EA-05-008

SUBJECT: FINAL SIGNIFICANCE DETERMINATION FOR A GREEN FINDING (NRC INSPECTION REPORT 05000395/2005007, VIRGIL C. SUMMER NUCLEAR STATION)

NRC Regulatory Conference VC Summer Nuclear Station

Drawing of 8 inch schedule 40 pipe with $\frac{1}{2}$ inch thick tubercles on top and $\frac{1}{4}$ inch thick tubercles on the bottom of the pipe

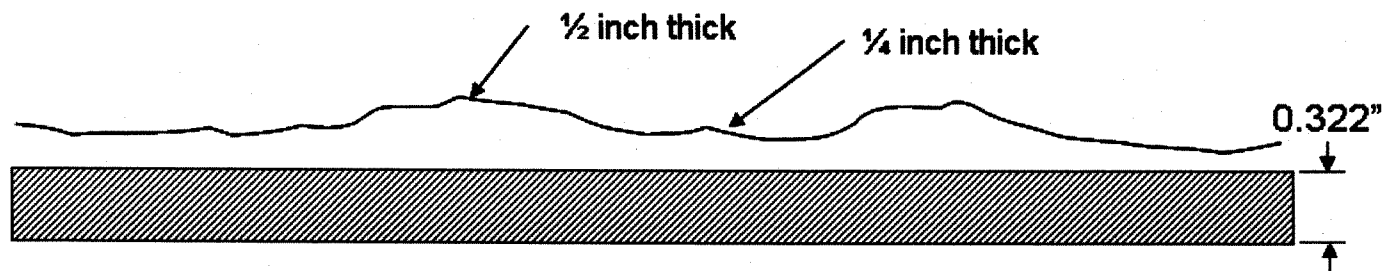
Limited Tubercle Buildup in SW Cross-Connect to EFW

- Tubercle layer is $\frac{1}{4}$ to $\frac{1}{2}$ inch thick
- Diameters generally between $\frac{1}{2}$ and $\frac{3}{4}$ inches.

Composition of Tubercle

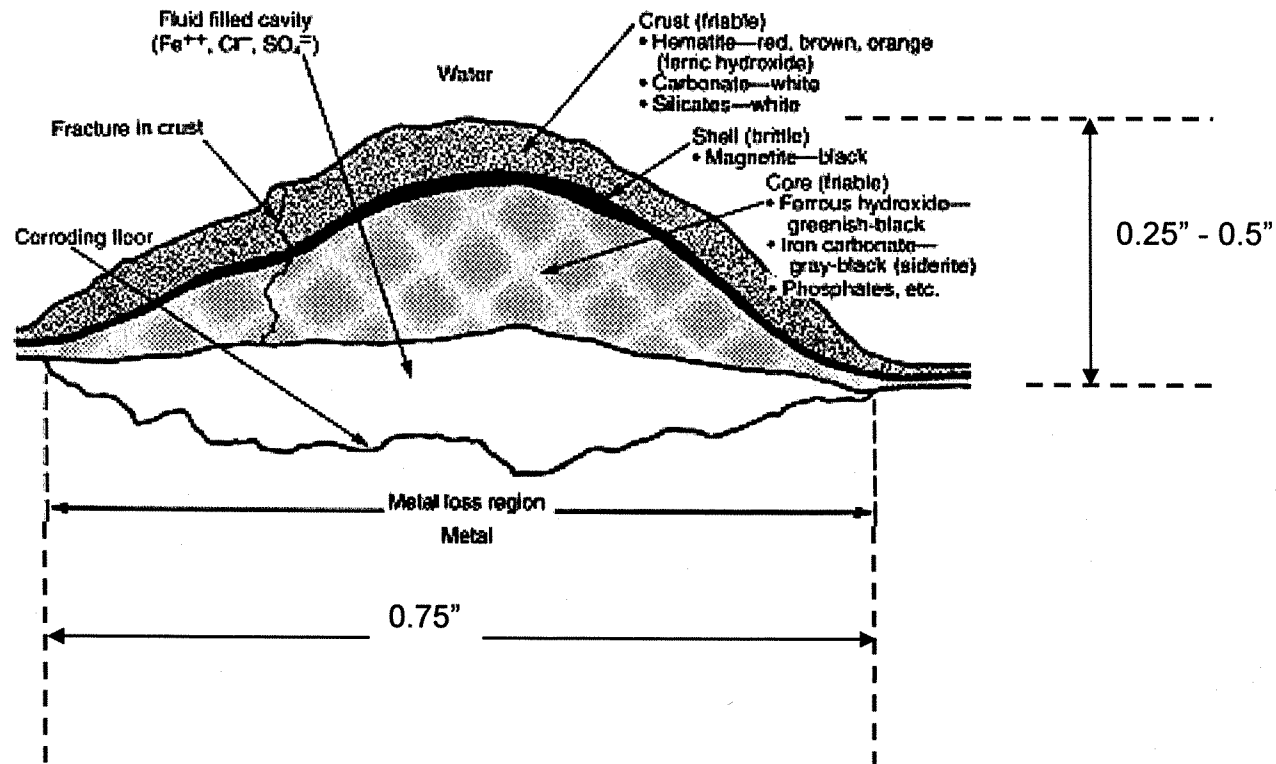
Tubercles have a friable (easily crumbled or pulverized), hematite outer crust; a brittle magnetite inner shell surrounding friable core material.

This composition differs significantly from sample material removed from the SW screen structure.

NRC Assumption

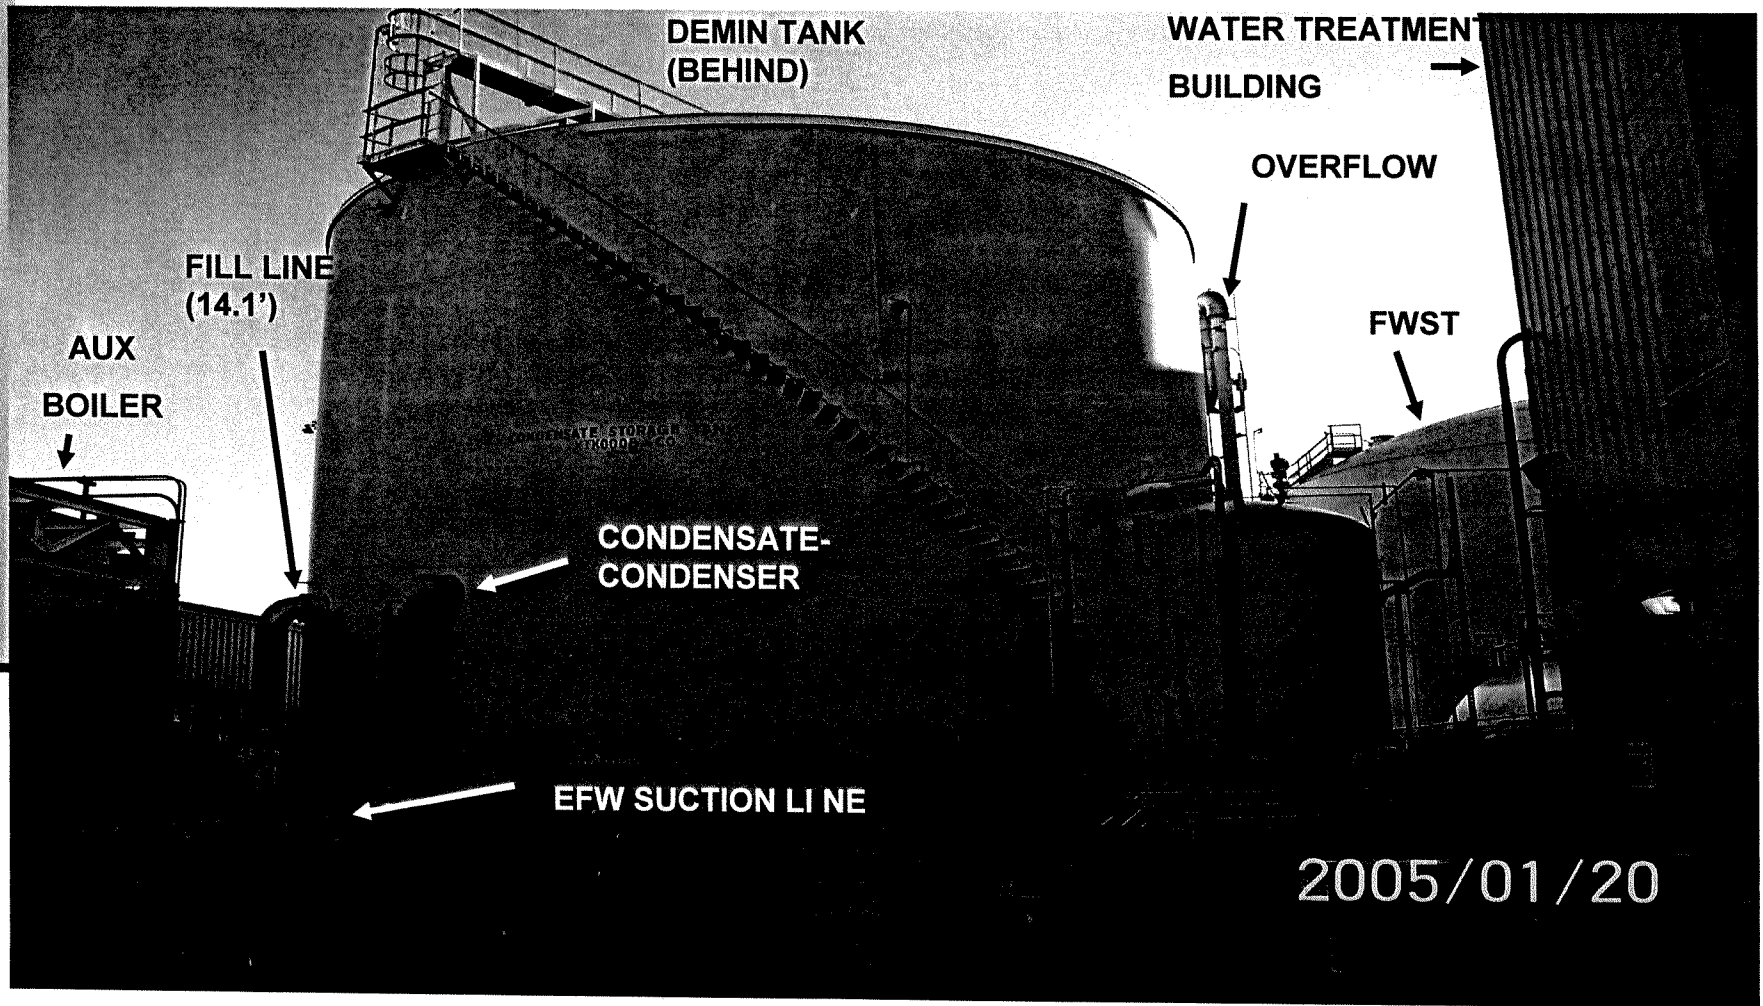
- The CST function is lost at the medium wind speed/intensity of an F2 tornado

CST Layout Drawing

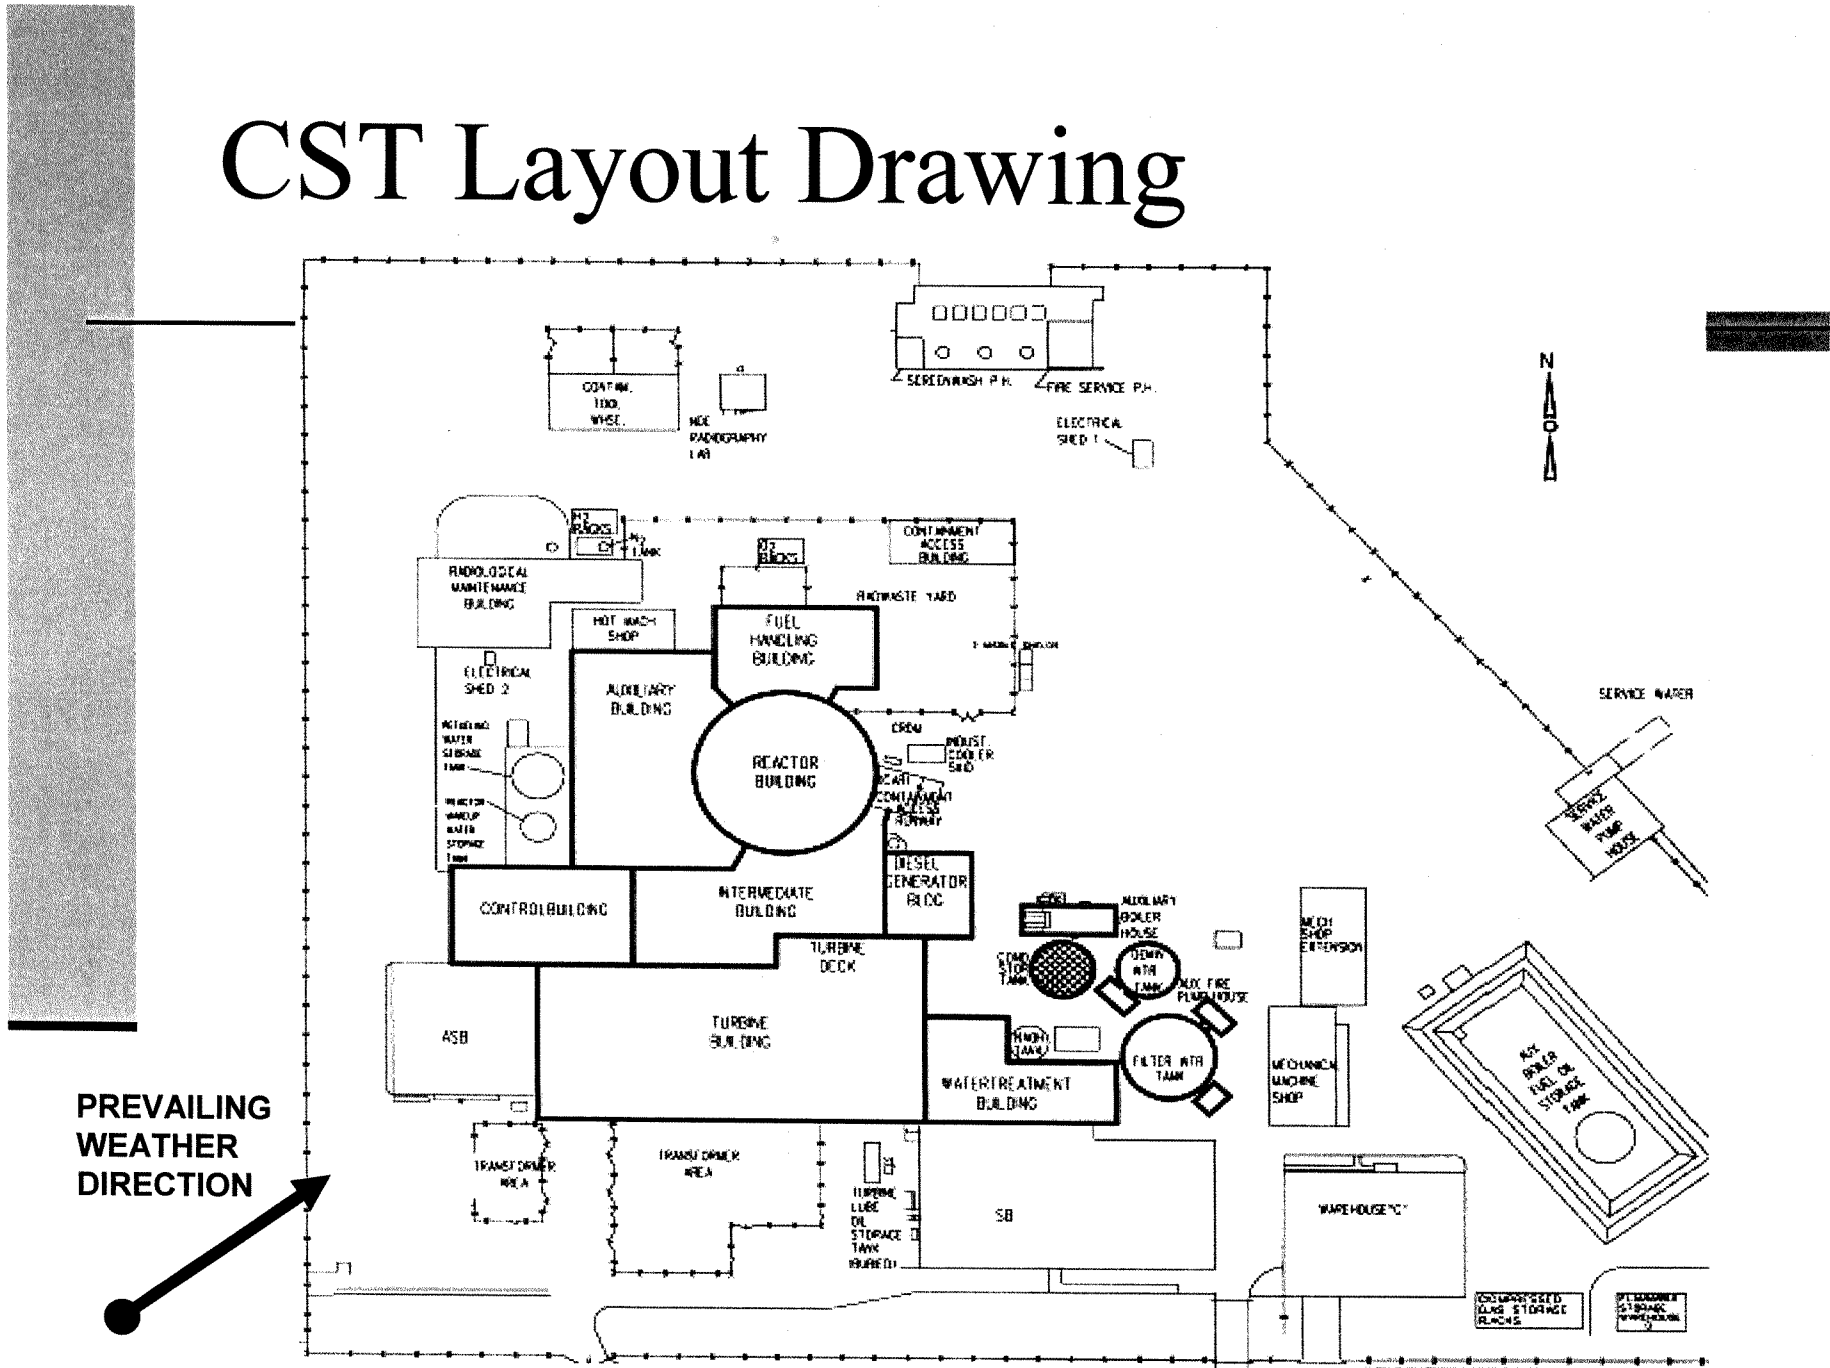
Seismic Design – Tank Shell Stress	19.6 psi (Top) 41.1 psi (Bottom)
F2 (157 mph) Max. Wind Load	0.44 psi
F2 (ΔP) Load	0.52 psi

Conclusion: CST Seismic Design Significantly Exceeds F2 Tornado Wind Loads

■ **NRC Assumption**

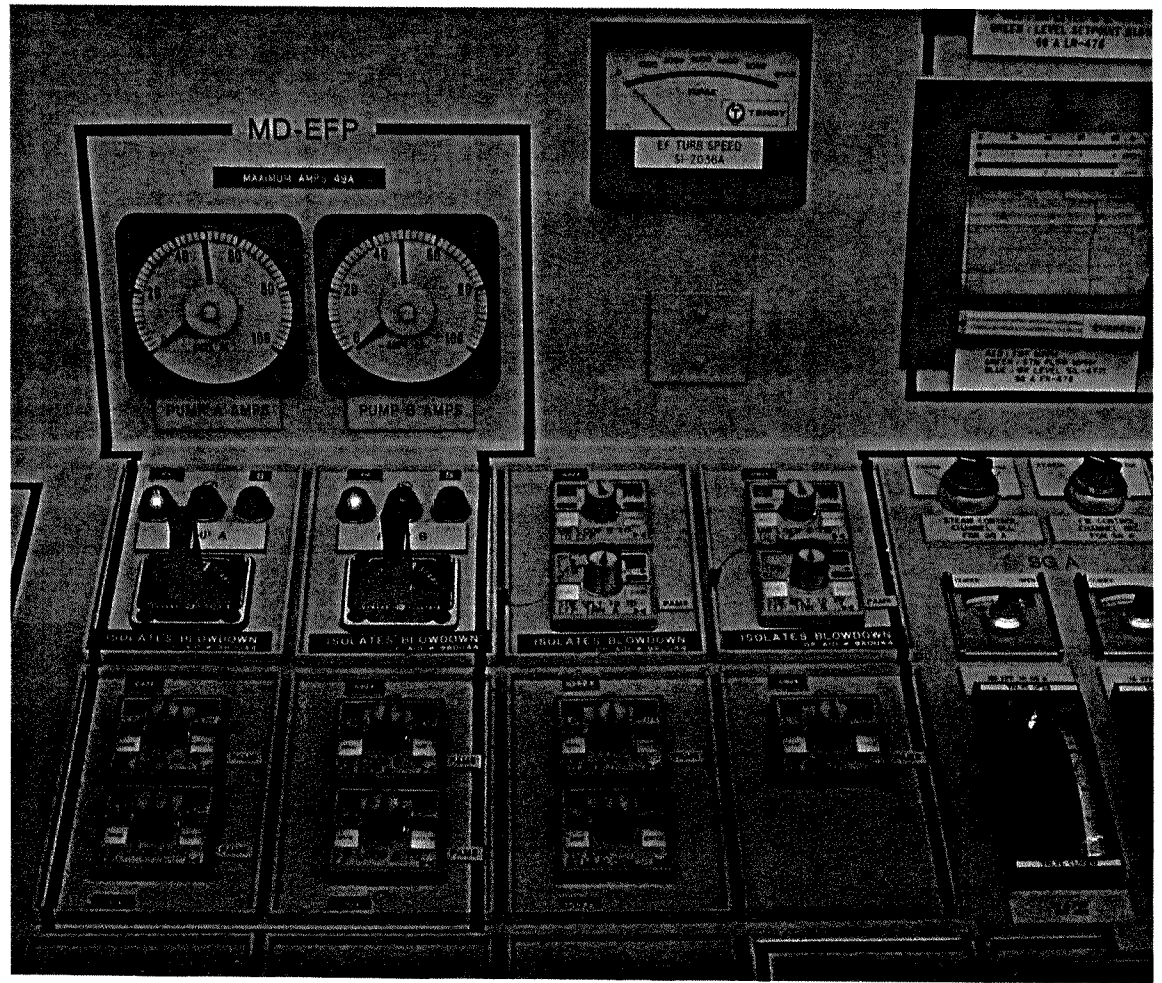
- Failure of CST as suction source for EFW system will cause a Rx trip during ensuing shutdown (Probability = 100%)
